**PLANNED UNIT DEVELOPMENT
STAFF REPORT****Date: May 5, 2016****DEVELOPMENT NAME**

Sandefur Properties, LLC

LOCATION1753 Spring Hill Avenue
(Southwest corner of Spring Hill Avenue and Mobile
Infirmary Boulevard)**CITY COUNCIL
DISTRICT**

CONTEMPLATED USEPlanned Unit Development Approval to allow shared
access and parking between multiple sites.**TIME SCHEDULE
FOR DEVELOPMENT**

PROPOSED SITE PLAN

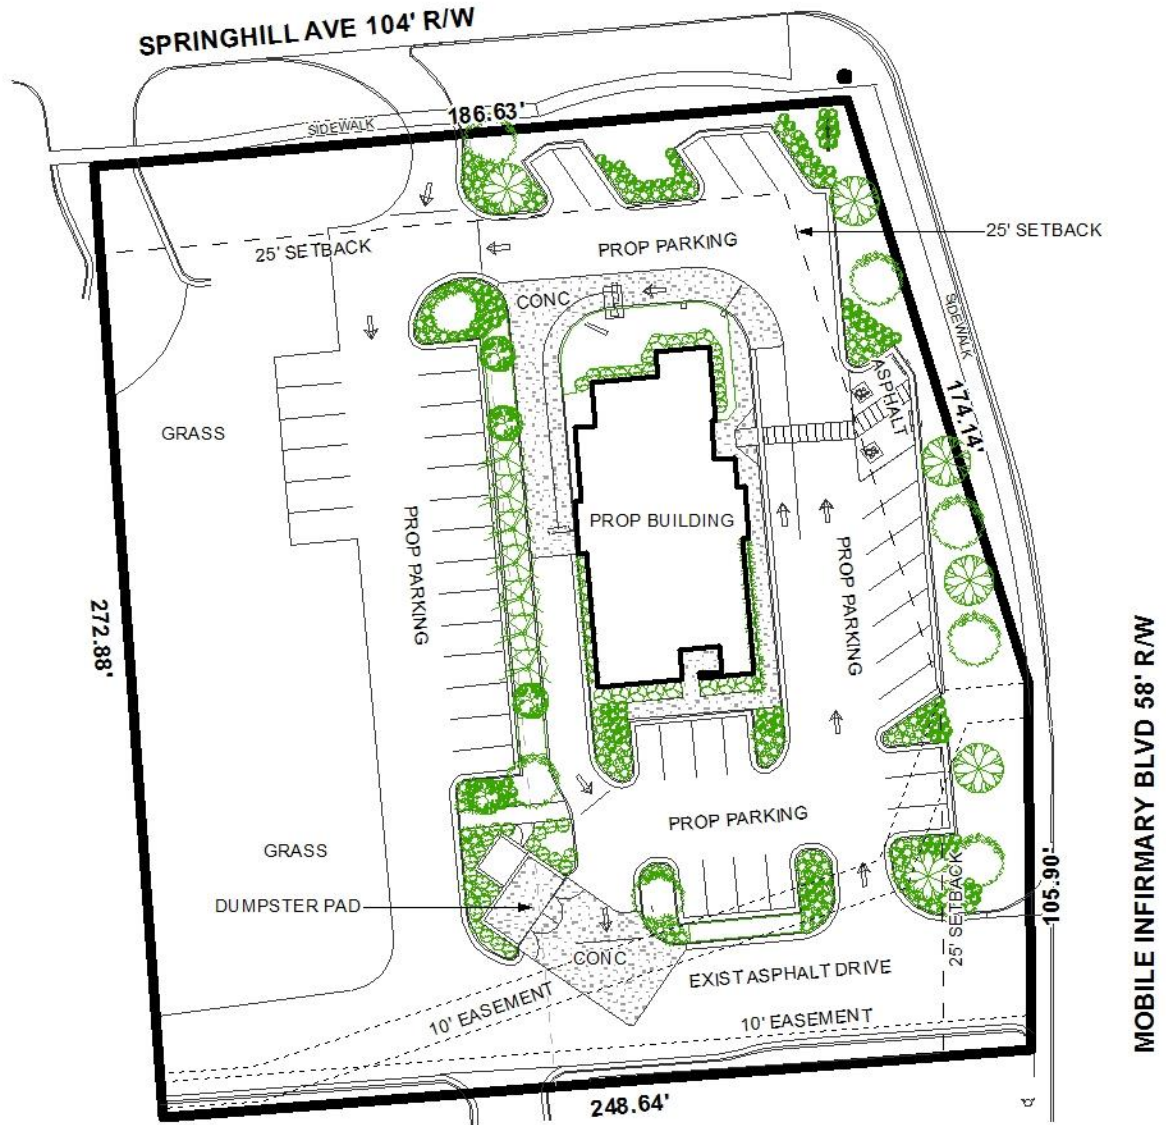
The restaurant is illustrated as being 3,652 square feet, requiring 37 parking spaces. The site plan illustrates 45 parking spaces, providing an overage, but a note on the site plan incorrectly states that 41 parking spaces will be provided. This information should be corrected on the site plan, if approved. Also, the West portion of the site should have either bumper stops or curbing provided to prevent vehicles from parking on the landscaped area.

The site plan illustrates a dumpster on the site, with a note stating to reference a page not provided with this application for details. If approved, the site plan should be revised to specifically state that the dumpster will have a sanitary sewer connection as well as a compliant dumpster enclosure.

The site plan illustrates several proposed signs including a freestanding sign, a "welcome" sign, a "thank you" sign, a menu board, and a pre-sell board. It should be noted that as long as the "welcome" and "thank you" signs do not have the name of the business or a logo, they are considered informational and do not require sign permits. All other signs will require a sign permit, however the pre-sell board may not be allowed on the site as one menu board is allowed per drive-thru lane, and the proposed layout of the site only indicates a single drive-thru lane. Also, it appears the proposed "welcome" sign may be located in a drainage easement; no signs are allowed within easements.

It should be noted that a proposed site plan illustrating tree plantings and landscape area was provided, however it does not show the site as being in compliance with Zoning Ordinance requirements. It appears, based on calculations provided, that landscaping is only proposed for one of the two lots to be developed; if both lots are used for the development, both must comply. Based on staff calculations, a total of 6 frontage trees are required along Spring Hill Avenue, 9 frontage trees are required along Mobile Infirmary Boulevard, and 3 parking trees are required. The site does indicate an existing 28" oak tree is proposed to remain on site, which provides 1 frontage tree credit and 4 perimeter tree credits. There is also an existing 31" pecan tree proposed to be removed from the site, for which a tree permit will be required.

- 1) obtaining a demolition permit for the existing structure prior to issuance of land disturbance or building permits;
- 2) revision of the site plan to correctly indicate the number of parking spaces provided;
- 3) indicate the dumpster will be connected to sanitary sewer and an enclosure in compliance with Section 64-4.D.9. of the Zoning Ordinance will be provided;
- 4) revision of the site plan to indicate either bumper stops or curbing along the West portion of the site to prevent vehicles from parking on the landscaped area;
